Customer : CU-DAR001 Dart Helicopters Services	Drawing Name : HELI UTILITY BASKET LH/RH 350/355
Job Number : 36694	
Estimate Number : 10208	
P.O. Number :	Part Number : D350607043
This Issue : 1/9/2008 S.O. No. :	Drawing Number : D350-607 REV F P7-9
Prsht Rev. : NC	Project Number : N/A
First Issue : / / Type : LARGE FAB ASSY	Drawing Revision : F
Previous Run : 36681	Material :
Written By :	Due Date : 2/5/2008 Qty: 1 Um: Each
Checked & Approved By : <u>JA 08.01.09</u>	
Comment : Est Rev: F as Per DS19318 06-01-24 JLM	
Est Rev: F ECN1068 07-12-21 DD

DESIGN <i>CP</i>	DRAWN BY <i>CP</i>	DART AEROSPACE LTD HAWKESBURY, ONTARIO, CANADA	
CHECKED <i>[Signature]</i>	APPROVED <i>[Signature]</i>	DRAWING NO. DSI 9318	REV. A SHEET 1 OF 1
DATE 06.01.06		TITLE WASHER ADDITION	SCALE NTS
A	06.01.06	NEW ISSUE

# DART SERVICE INSTRUCTION

TO AMEND INSTALLATION INSTRUCTIONS D350-607 REV. F

**Figure 5- Basket Replacement Parts**  
(D350-607-043 Heli-Utility-Basket™)

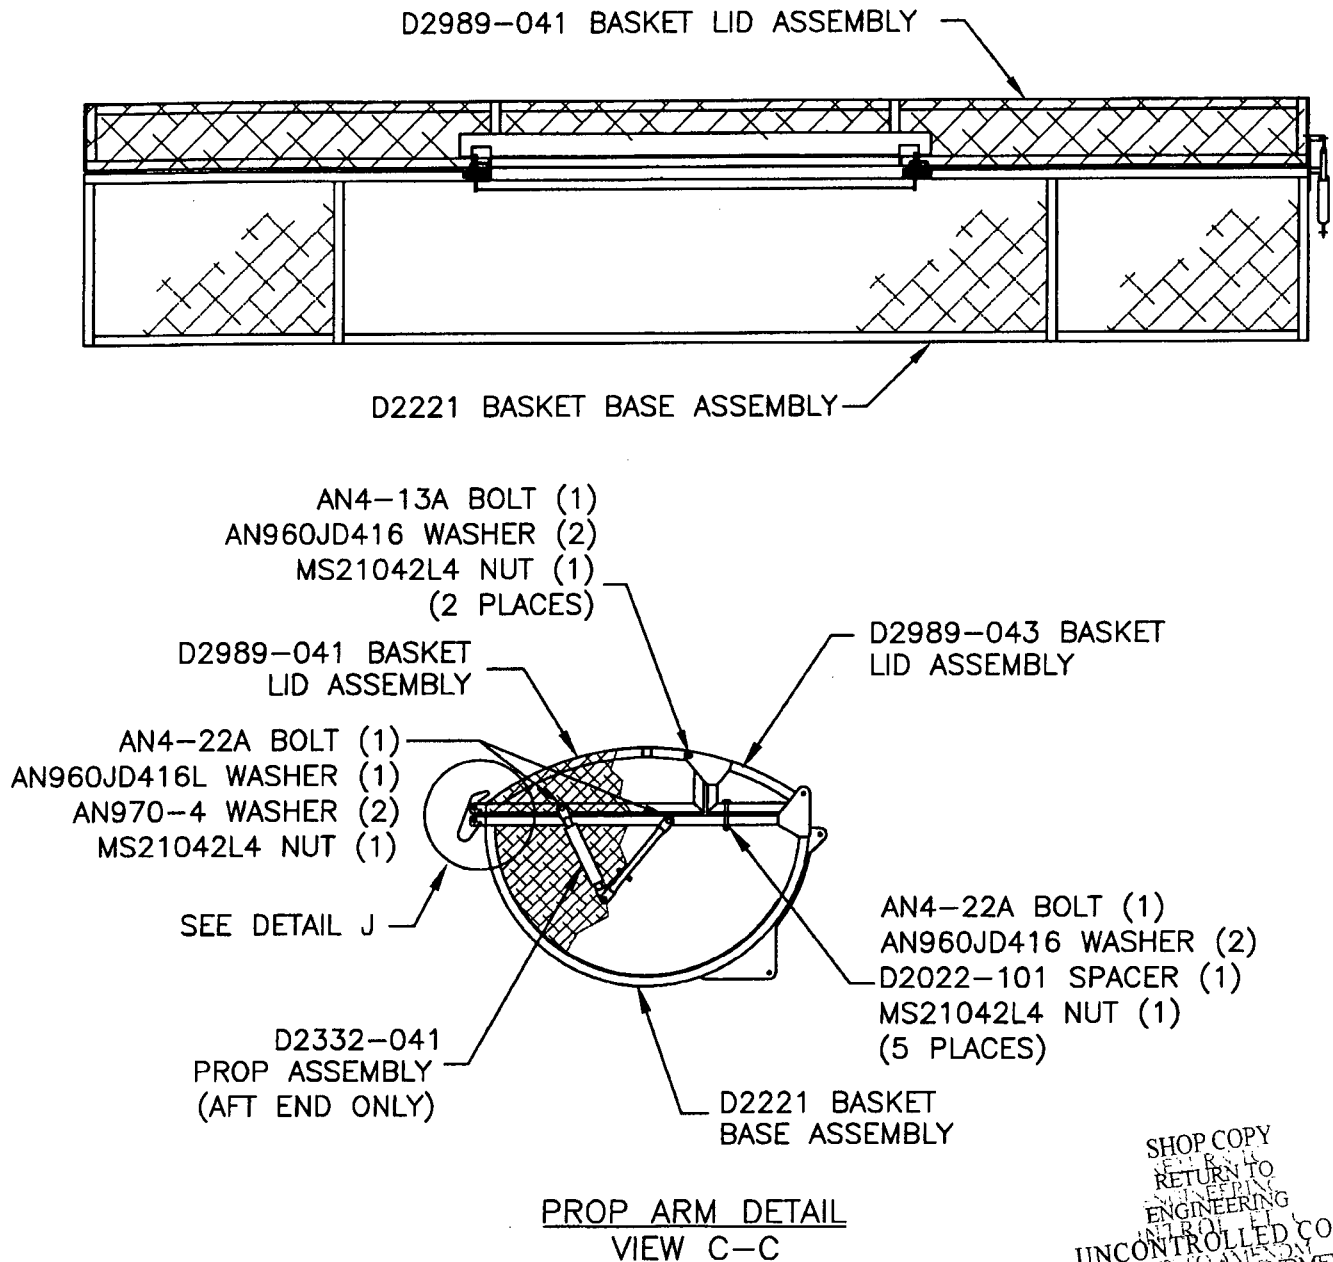
The corrected bolt stackup from Figure 5 of installation instructions D350-607 Rev. F is given below:

AN4-13A BOLT (1)  
AN960JD416 WASHER (1)  
HINGE PLATE (REF)  
**NAS1515H4 WASHER (1)**  
BASKET FRAME (REF)  
AN960JD416 WASHER (1)  
MS21042L4 NUT (1)  
(2 PLACES)

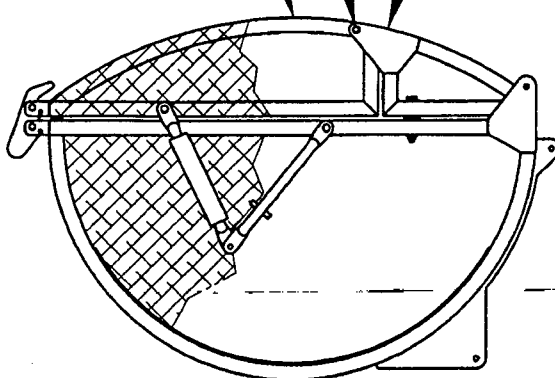
To reduce the possibility of damaging the finish, a **NAS1515H4** washer (2 places) has been added between the hinge plate and basket frame on the **D350-607-043/-047 Heli-Utility-Basket**.
